Residential LIM Application
23 Lithgow Dr WHANGANUI

Land Information Memorandum (LIM)

23 LITHGOW DR WHANGANUI

JOB TITLE A NEW SINGLE STOREY DWELLING AT LOT 28 LITHGOW DRIVE, WANGANUI	DRAWING TITLE LOCATION PLAN
---	--------------------------------

DESIGN:	MM
DRAWN:	MM
CHECKED:	MM
DATE:	MARCH 2008
SCALE:	NTS
JOB No:	REY 082
SHEET NO:	S 03

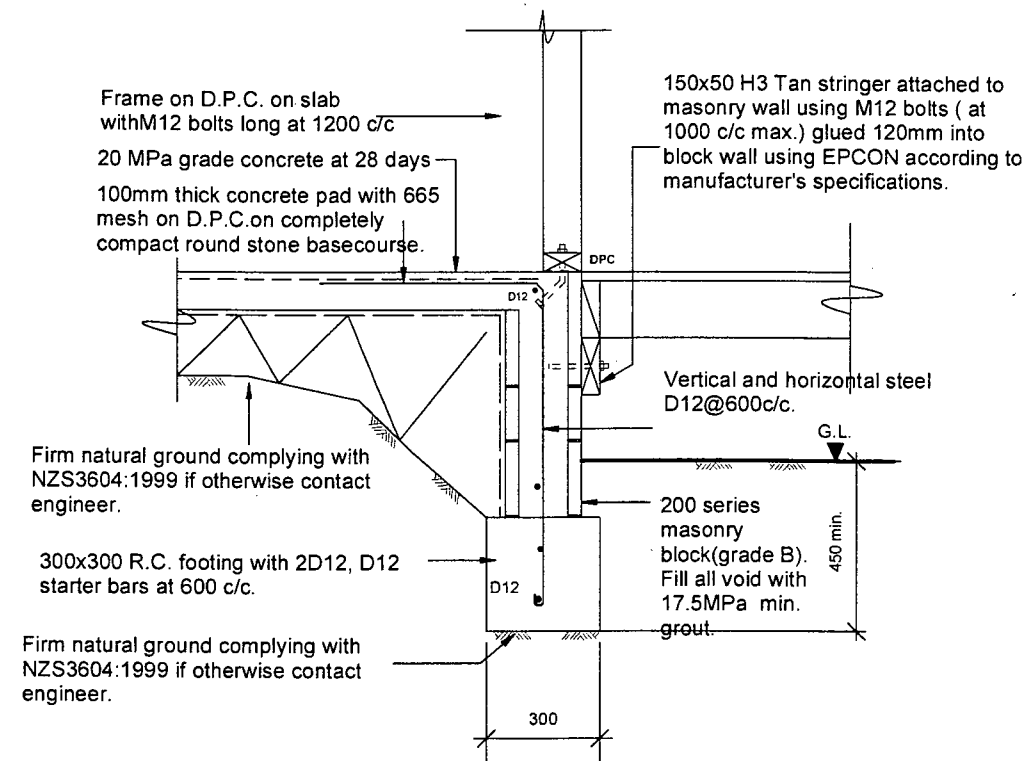
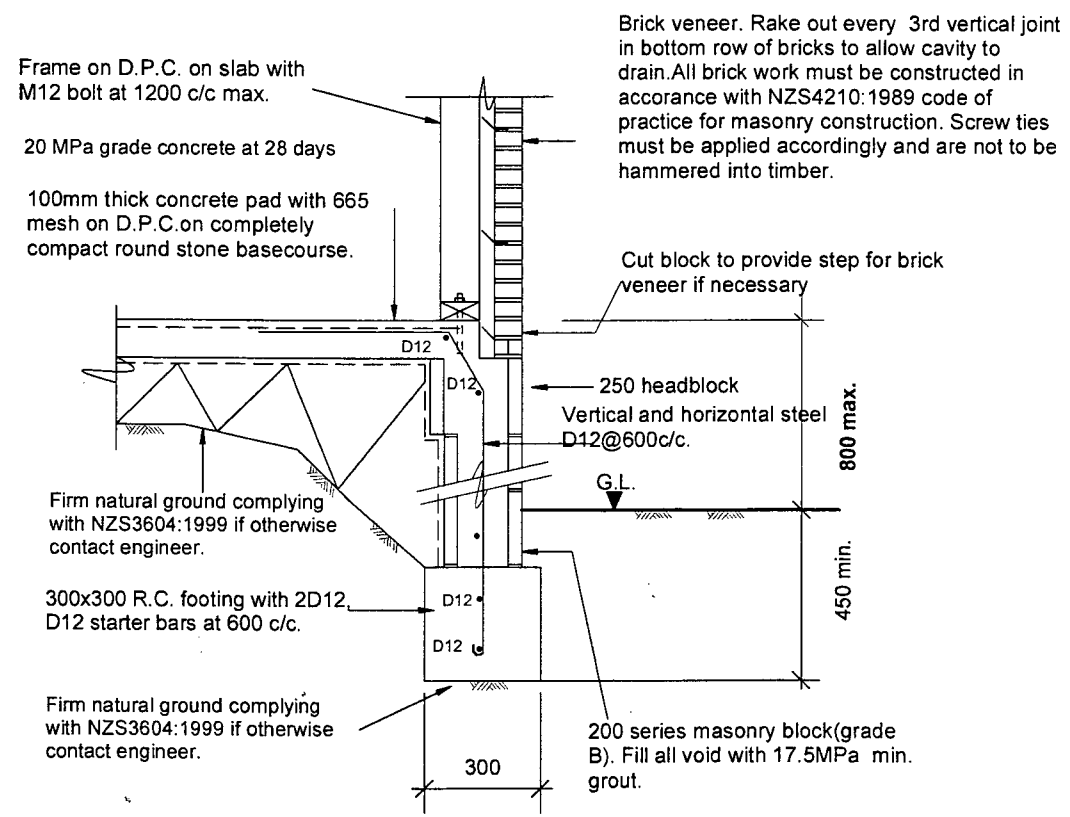
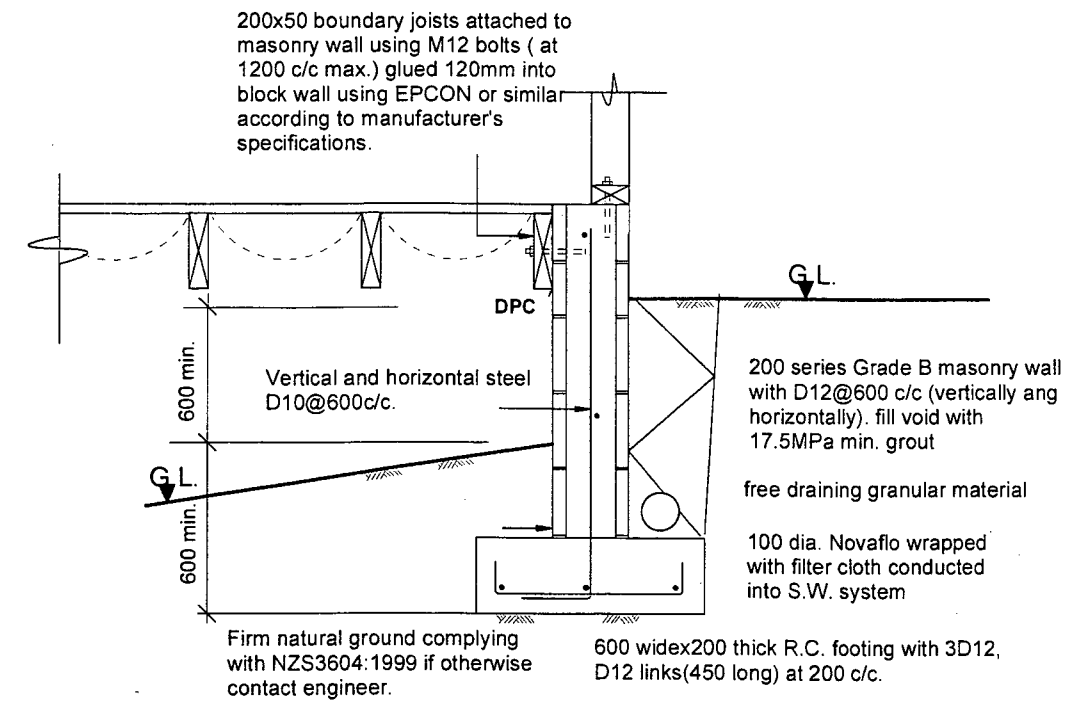
6. The engineers supplied R.C. footing plan view detail on sheet S01 specifies a different reinforcing layout to the footing details on sheet S03, please clarify the design.
(Andrew Morris - Building Control Officer)

Item 5 & 6. Revised sheet S01, S02 and S03 show round stone base-course, soil type (sand) etc.

DRAWN TMR	DATE 21 SEPT. 2010	SHEET NO ND-04
SCALE 1:100	JOB NO 2195

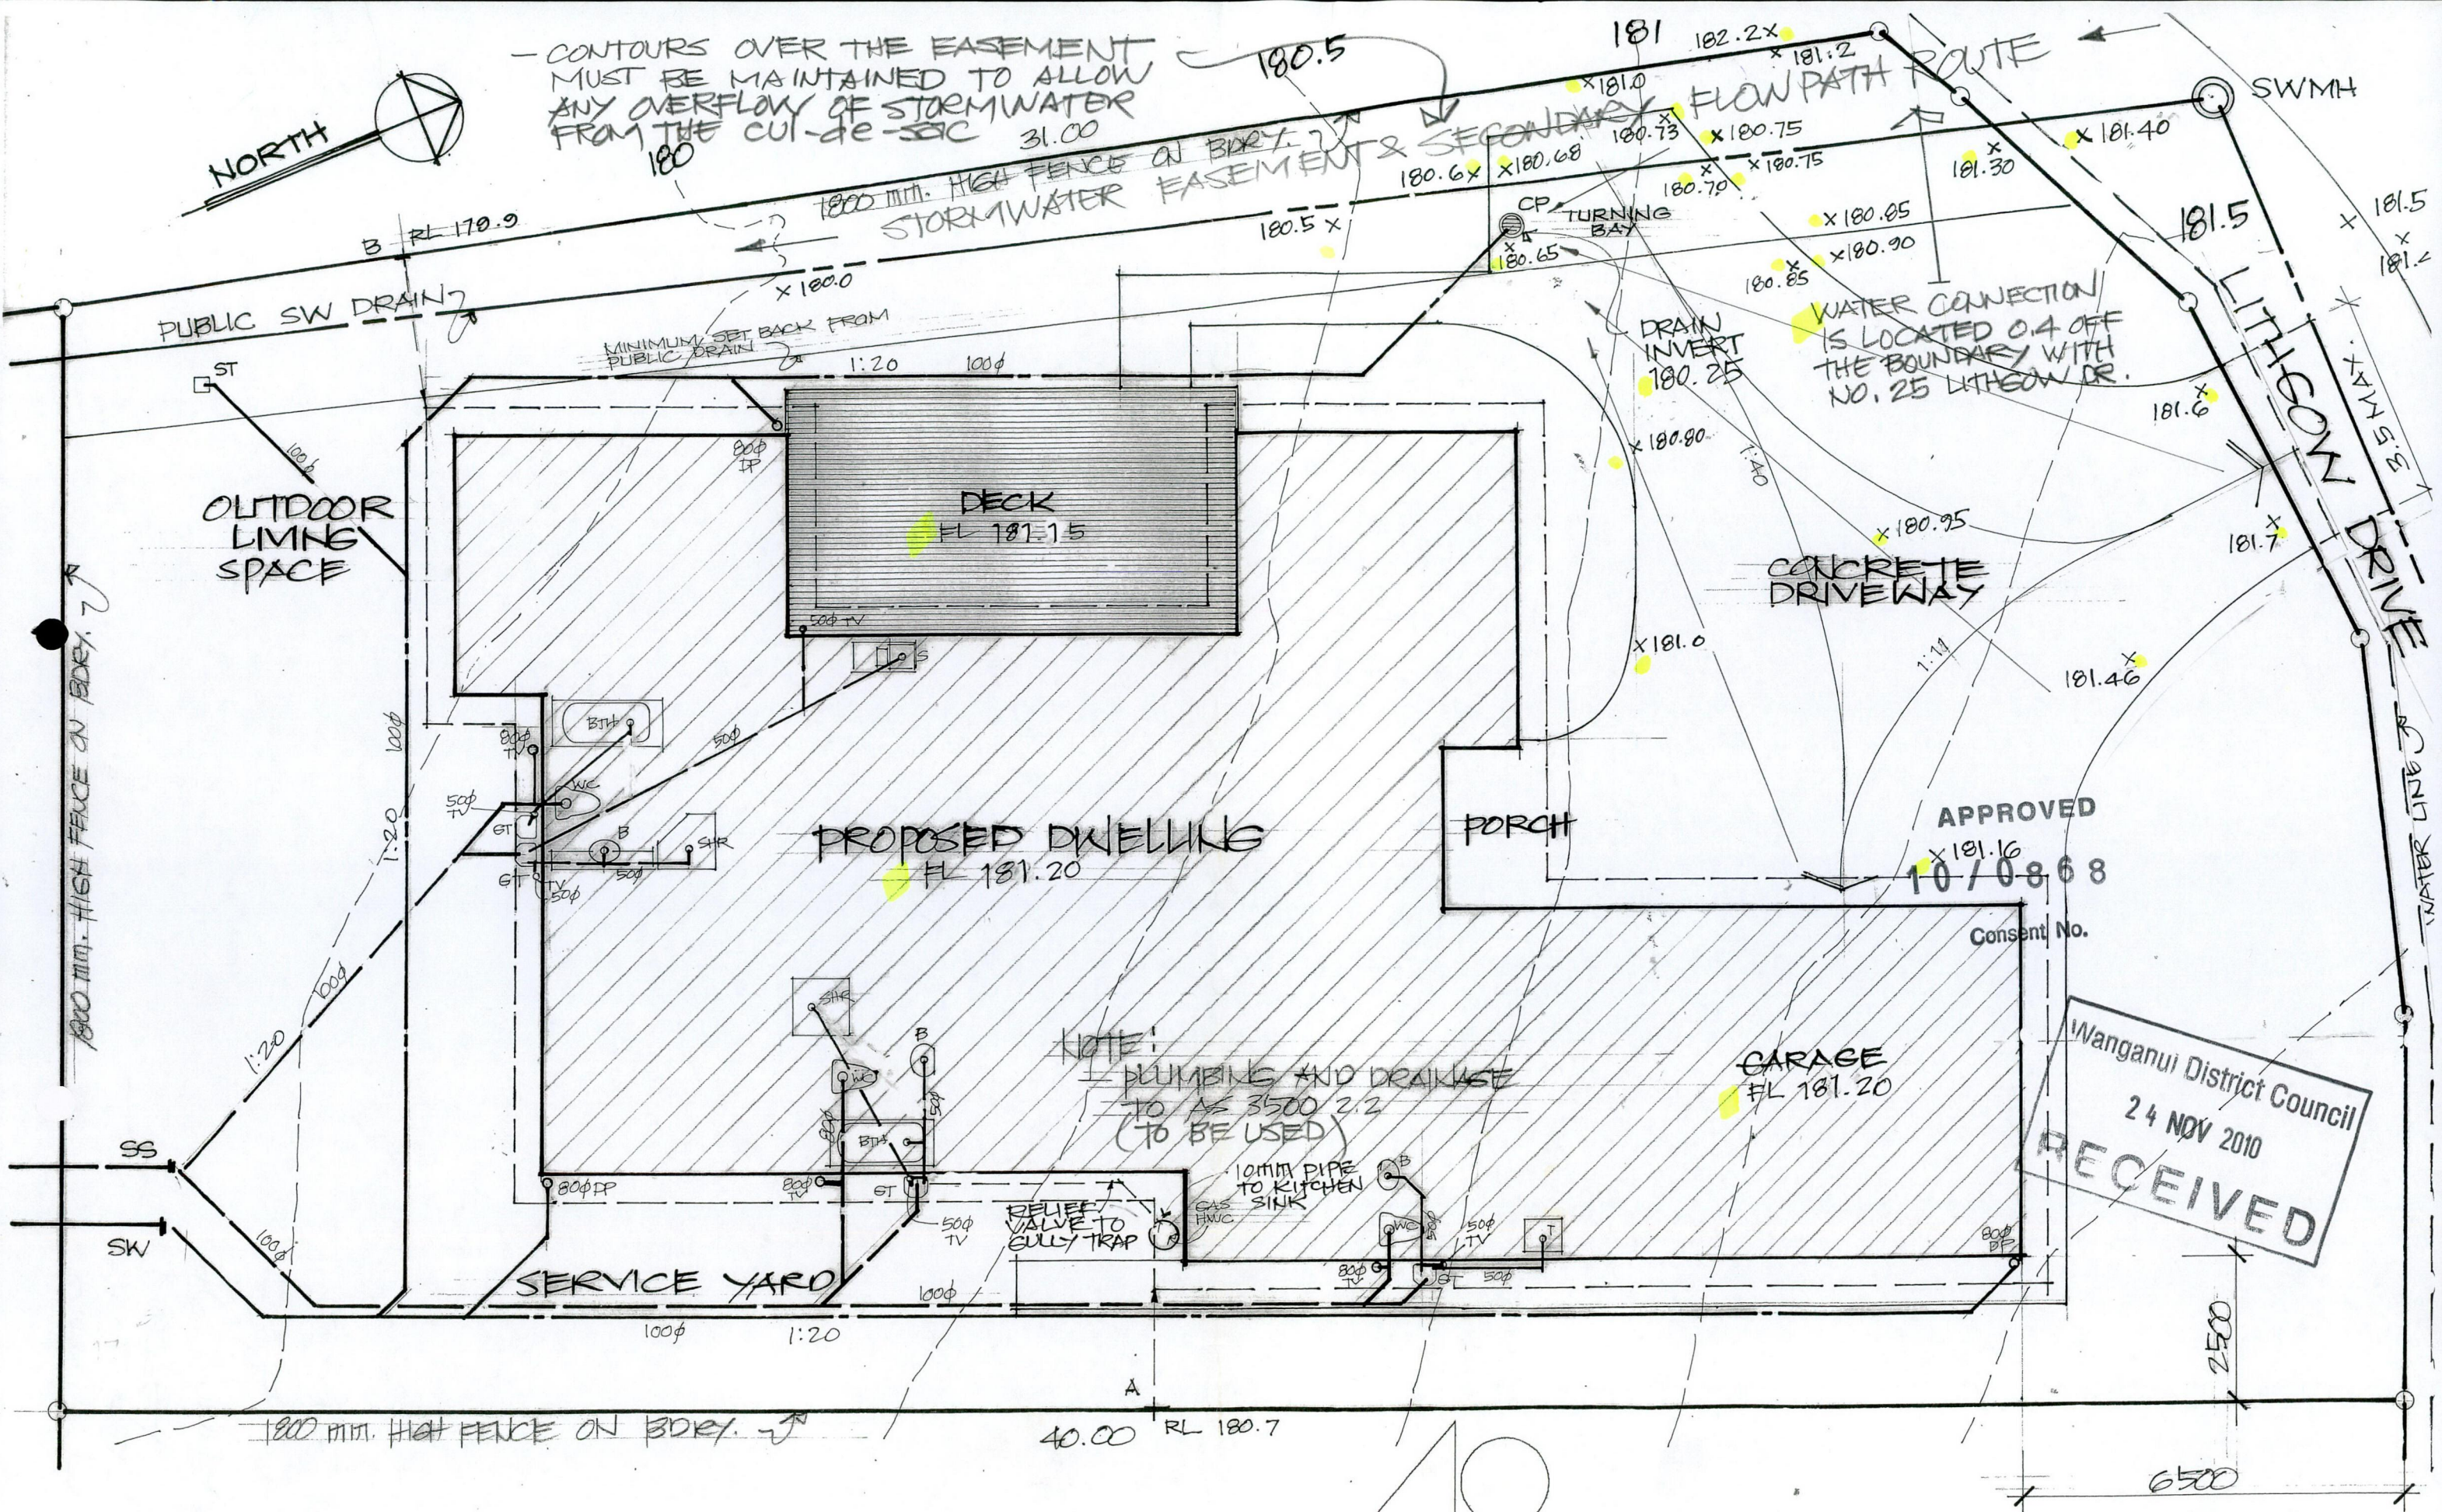
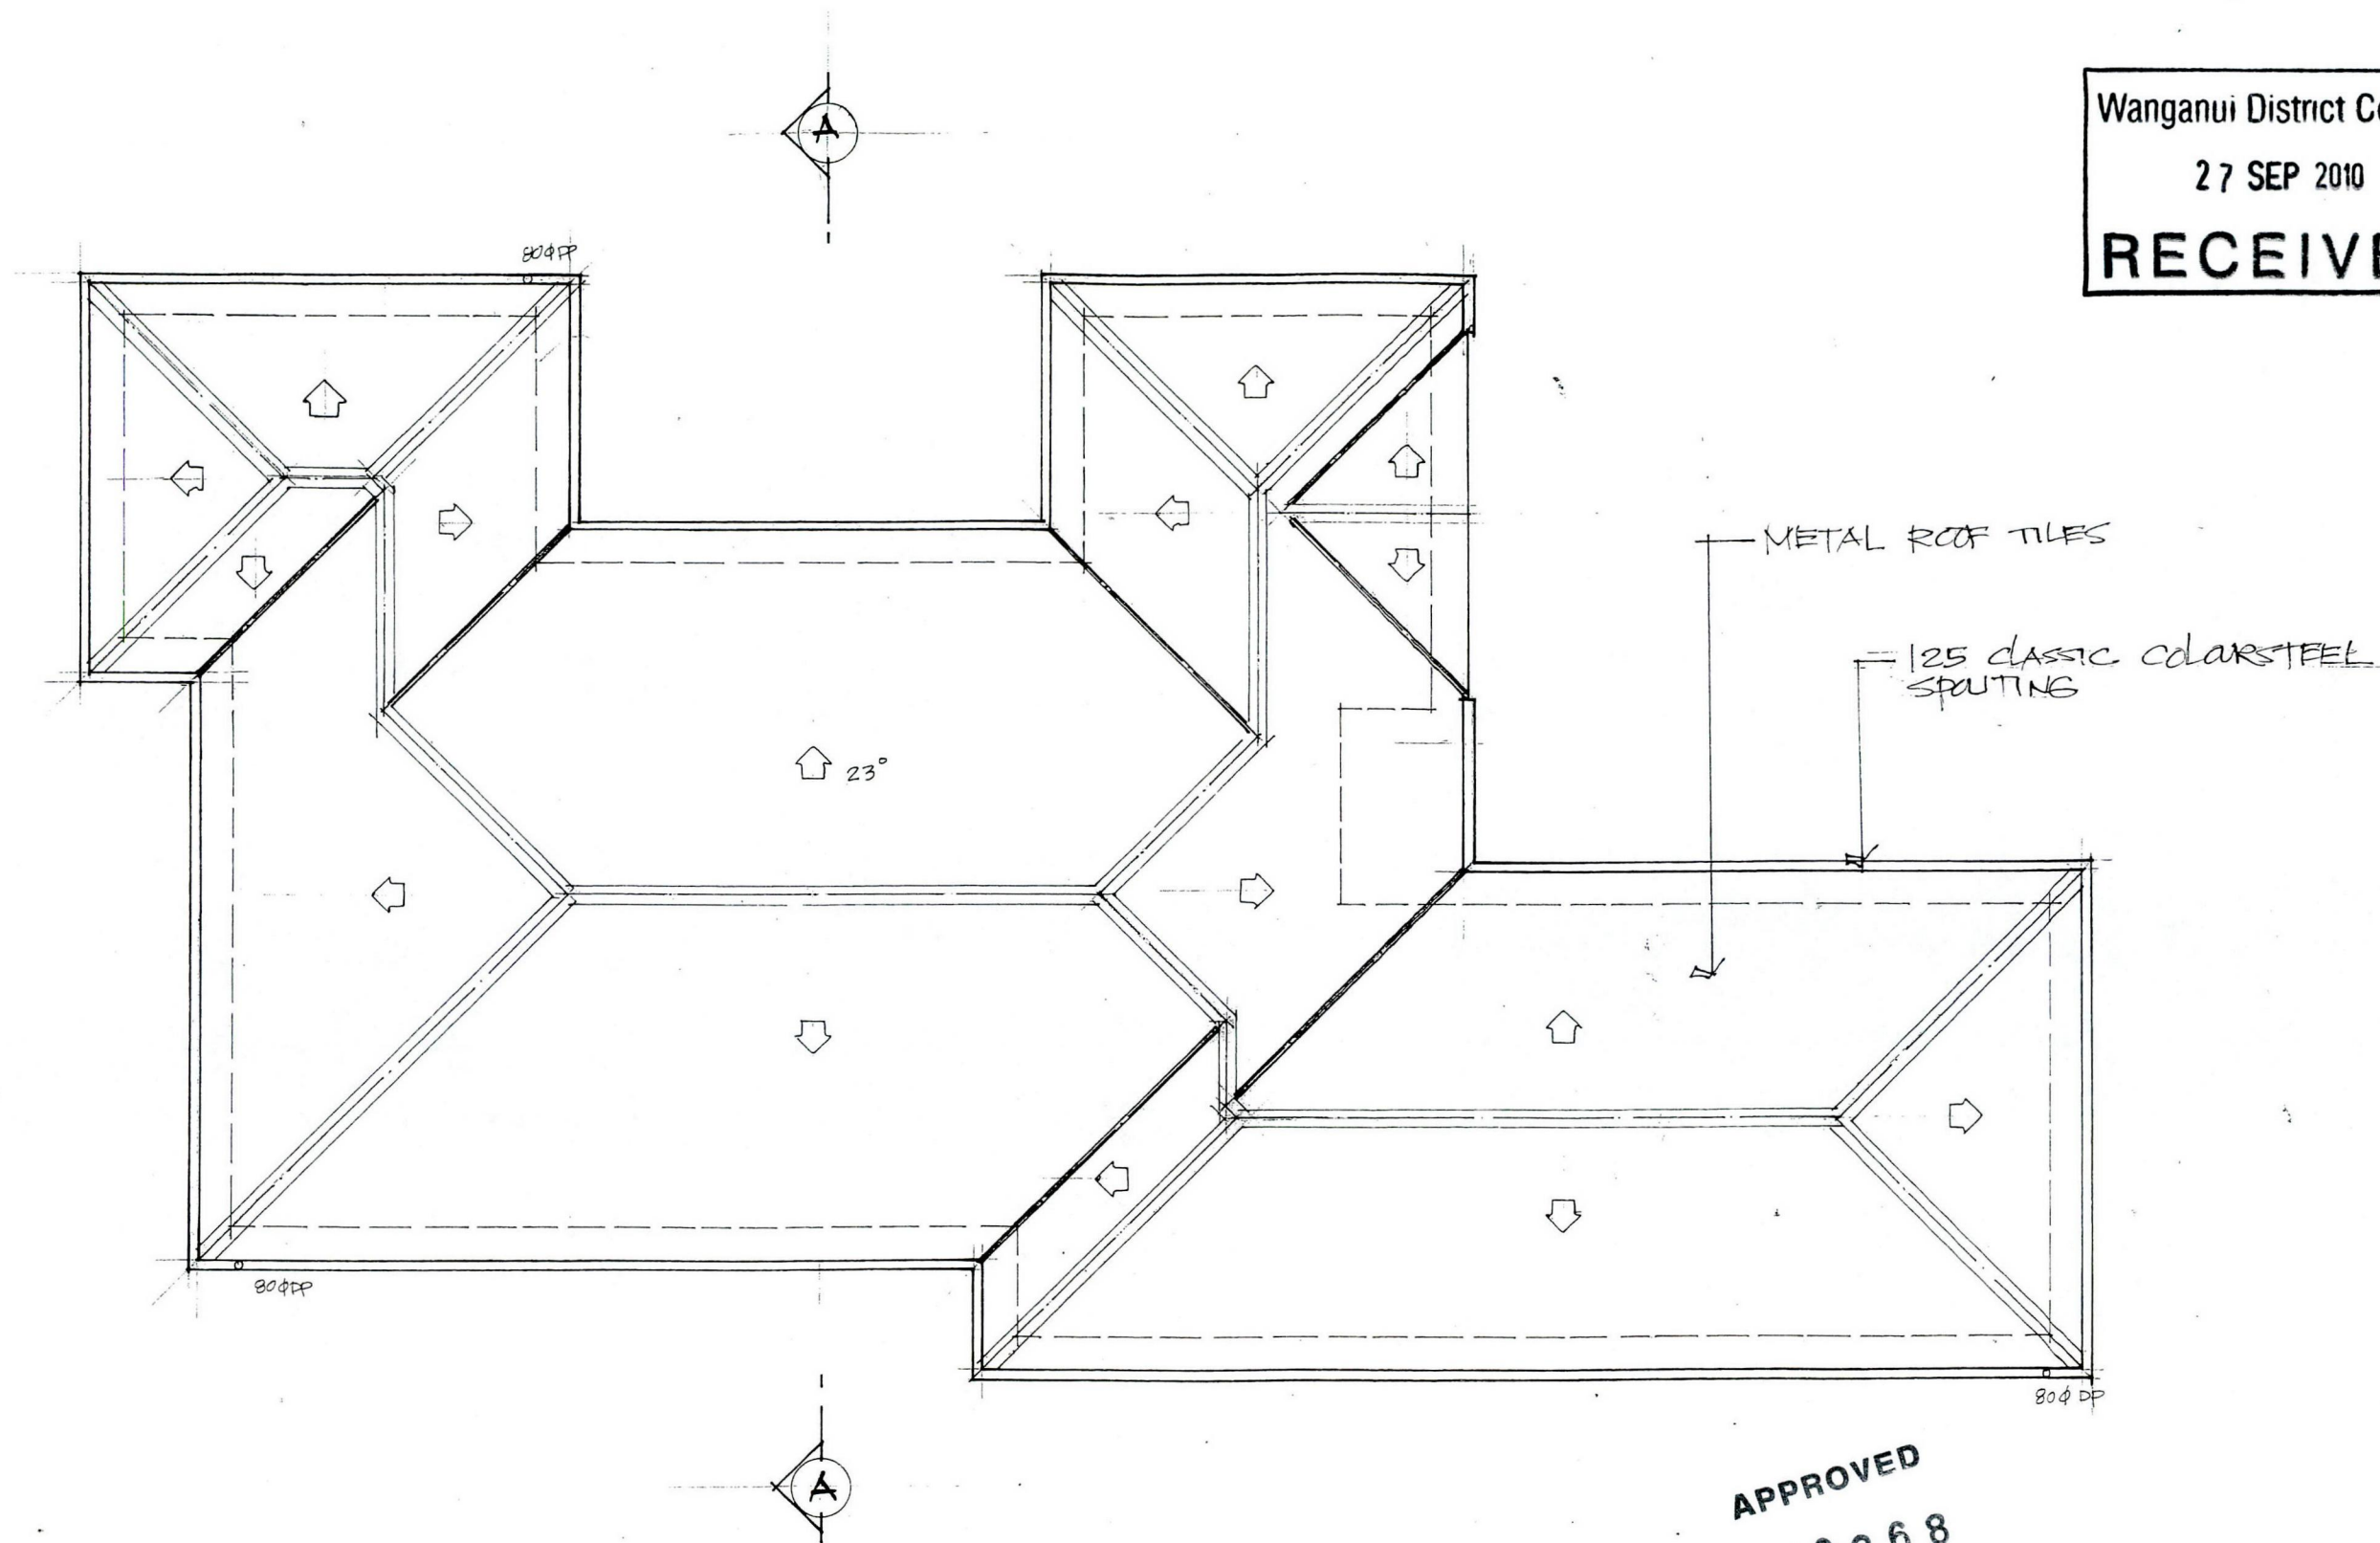
- ND-08 9. The supplied roof plan (sheet ND-04) does not match the supplied truss plan with regards to the gable over the lounge window W1, please address. (Andrew Morris - Building Control Officer)
